Amended Statement of Environmental Effects

This amended Statement of Environmental Effects (**SEE**) has been prepared by Urbis Ltd on behalf of City of Newcastle Council (**the Applicant** or **CN**) to support Regionally Significant Integrated Development Application DA2025/01321 (**the DA**) for the Stage 2 revitalisation of Newcastle Ocean Baths at 30 Shortland Esplanade, Newcastle East (**the site**). The site is located on Awabakal Country.

5.2 Response to Council RFI

Figure 4 Comparison of Originally Proposed and Amended Internal Ground-Floor Layouts

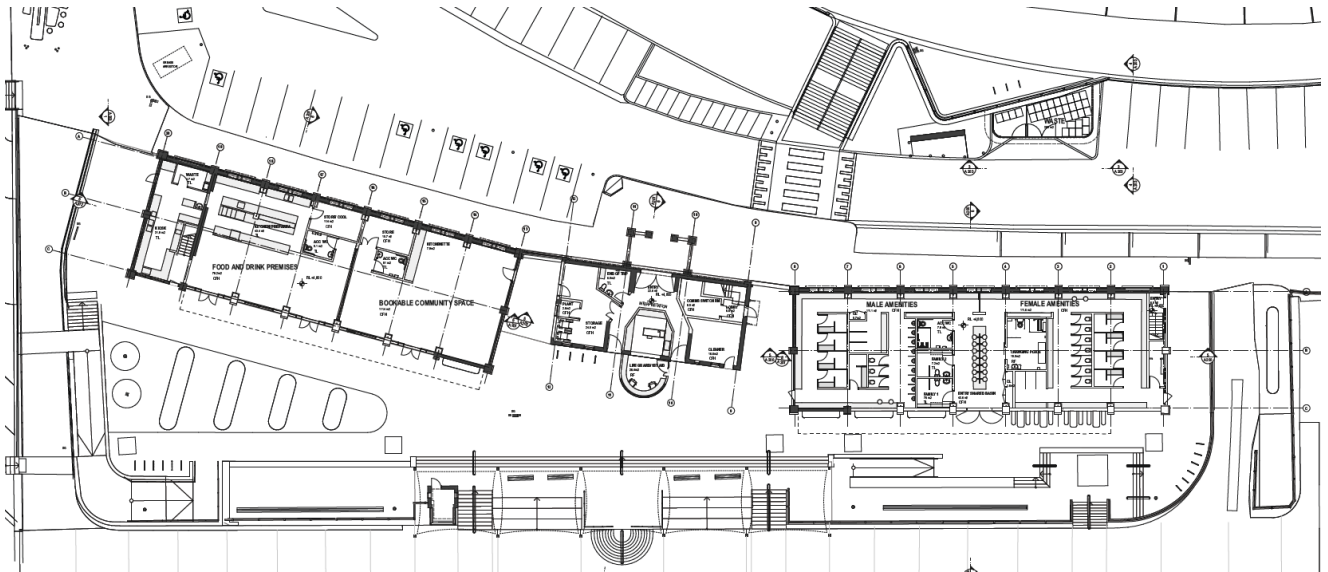
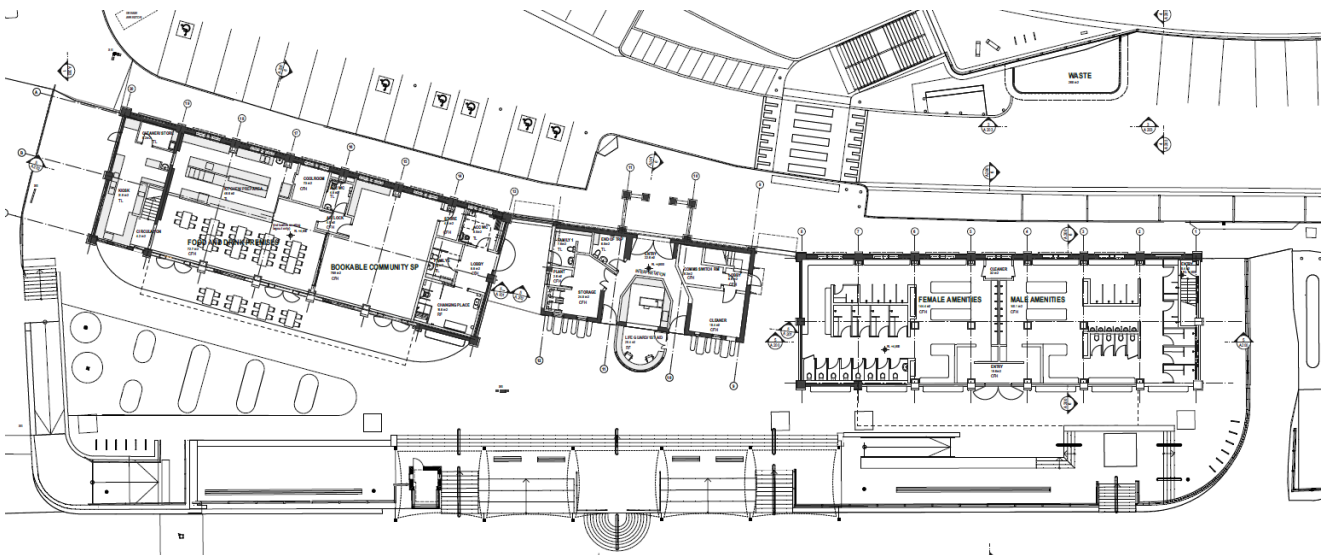
1.4.6 Amenities The submitted plans indicate an enclosed roof design for the change rooms. Additional information is recommended to address design options explored and considerations leading to the enclosed design, including why each option was discounted, and CPTED considerations including how the design mitigates crime-related risks and strategies for surveillance, lighting and related matters.	As shown in the amended architectural plans, the roof design has been amended to remove the wavy form and introduce a flat roof to provide greater light and ventilation in consideration of the community concerns regarding surveillance, lighting and related matters and have been updated proposal. The amended SoHI issued with this application includes a detailed options analysis for key elements of the proposed scheme, including the plan arrangement, roof design, and public domain.

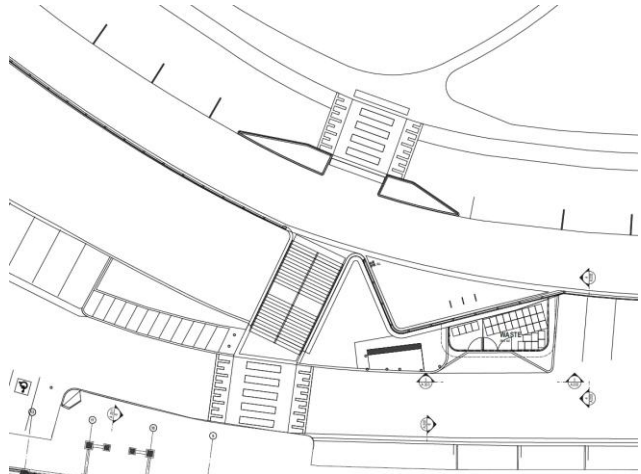
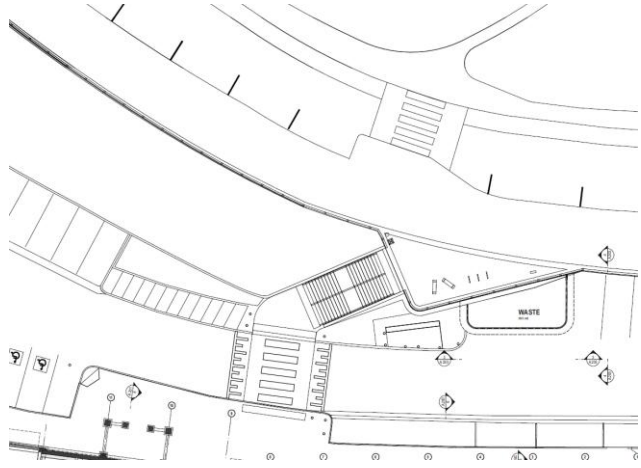
2. Engineering	
2.1 Proposed stairway connection to Shortland Esplanade – landings	Stairway connection has been changed as part of the amended proposal with the staircase angle being rotated to ensure that sufficient landing area and run-up space is provided and that there will be

Council Comment	Response
The Access Report by Credwell is to be amended to include the proposed stairway connection to Shortland Esplanade with particular focus on the sufficiency of landing areas at the top and bottom of the stairs, including run-up space and pedestrian visibility to drivers in the car park.	sufficient pedestrian visibility to drivers in the car park. A comparison of the previous and current examples are extracted below: <i>Original submission</i>  <i>Amended proposal</i>
